**Clayton**  
ENVIRONMENTAL  
CONSULTANTS

November 23, 1994

Clayton Project No. 47616.01

**Subject:** Apparent Groundwater Mound Issue/Leak Investigation for  
Powell Street Plaza

Locations of Possible Water  
Infiltration Sources  
Powell Street Plaza  
Emeryville, California

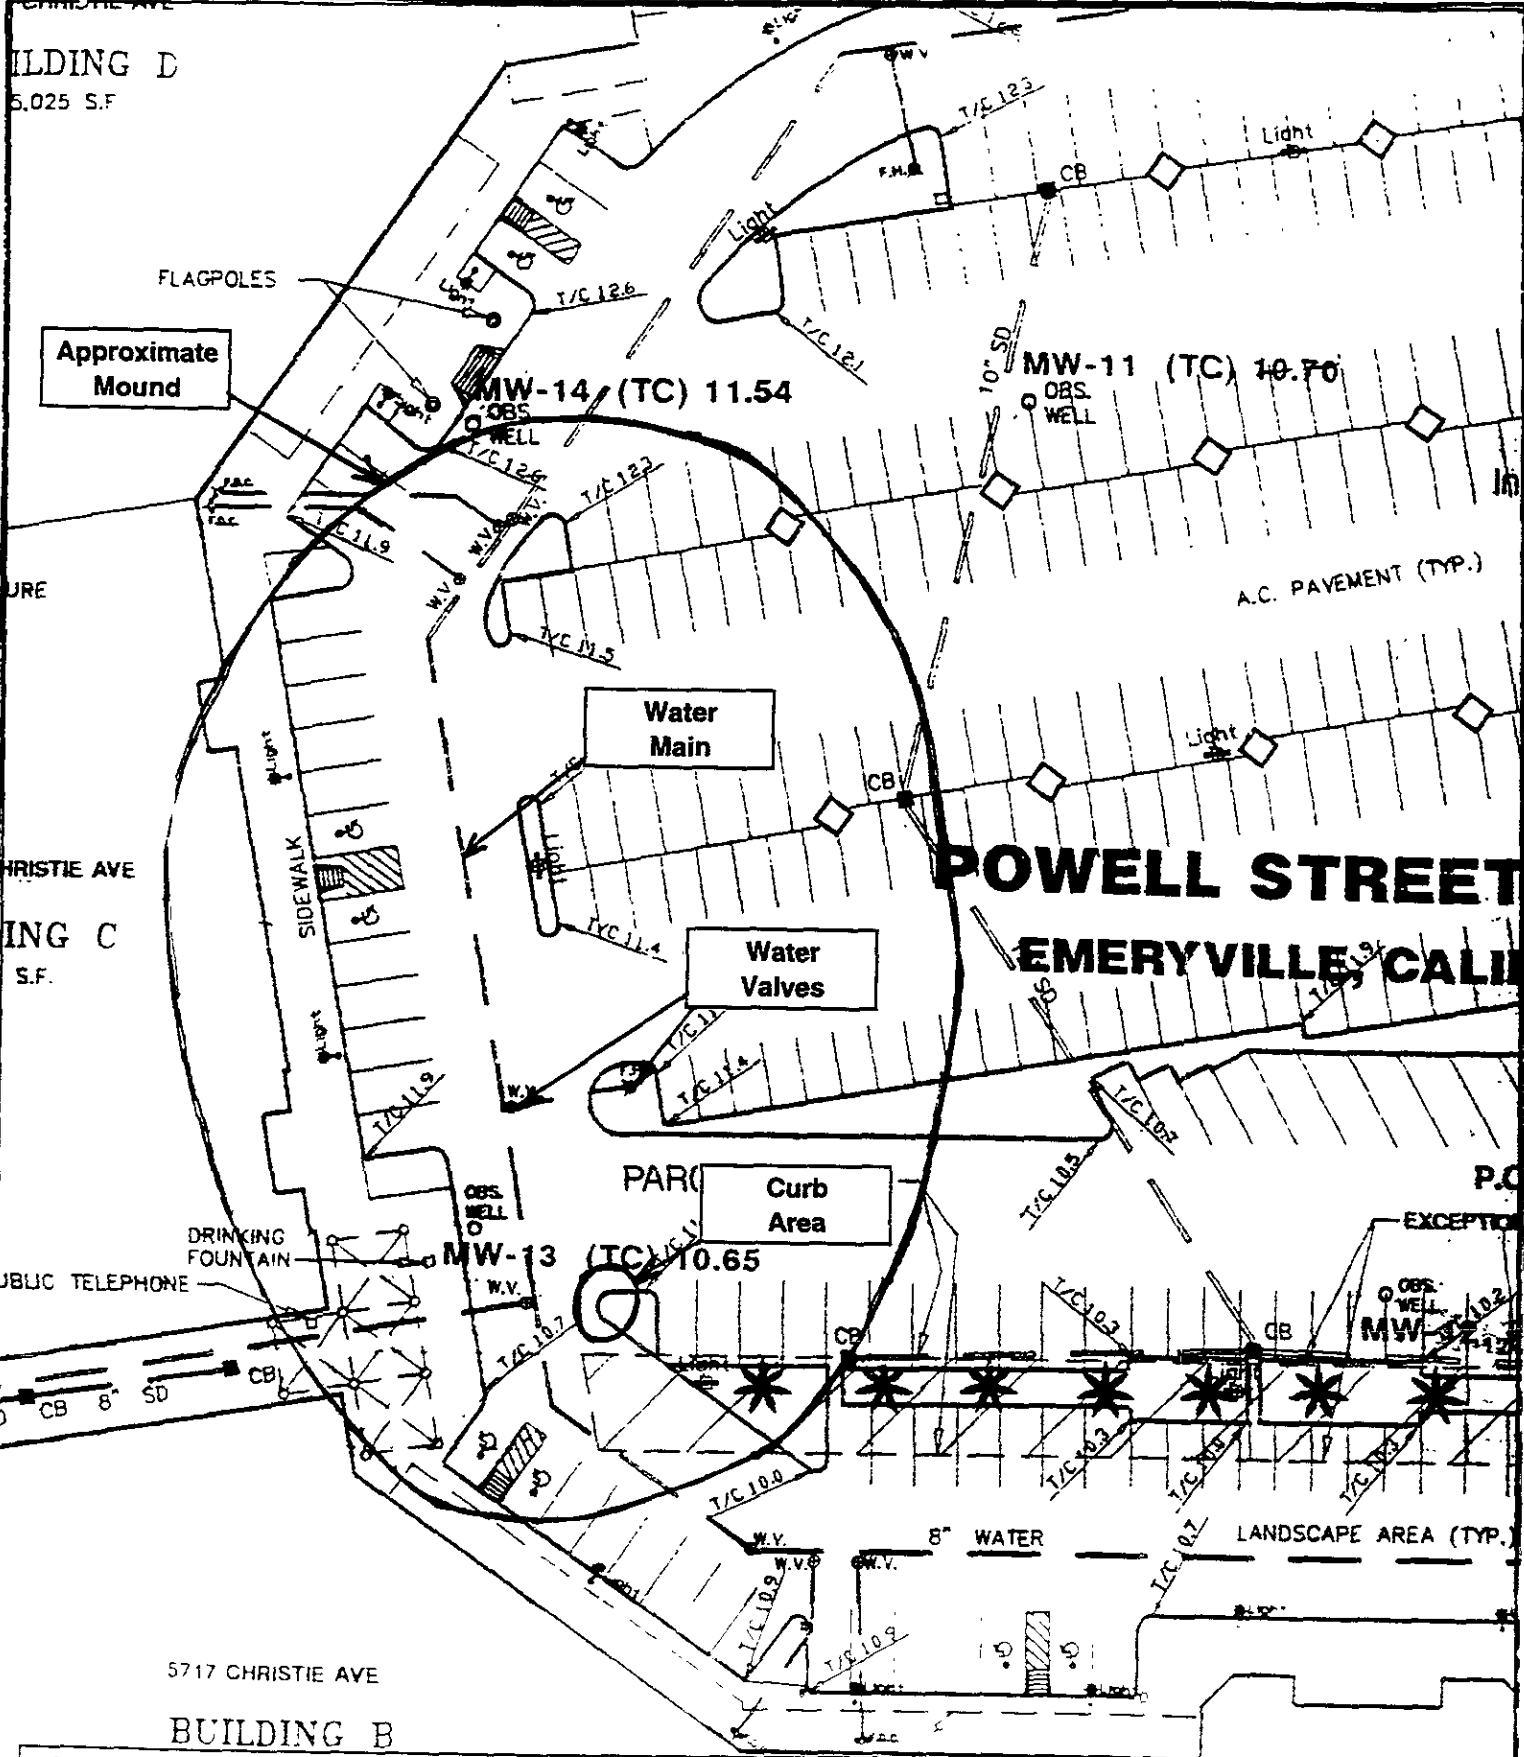
As noted on the Cullen Engineering Associates drawing labeled Plate 3 of your June 3, 1994 letter, an 8-inch water main and associated valving runs beneath the area of the apparent groundwater mound. This line is part of the fire suppression supply loop which runs along the front and rear sides of the buildings and supplies the various fire hydrants at the site. Two meters register usage of the fire suppression system. According to East Bay Municipal Utility District (EBMUD) billing records, over the four month period February 2, 1994 to June 6, 1994, only one unit of water was used at each, consistent with the amount consumed in testing. Therefore, the fire suppression system is not a source of infiltration water.
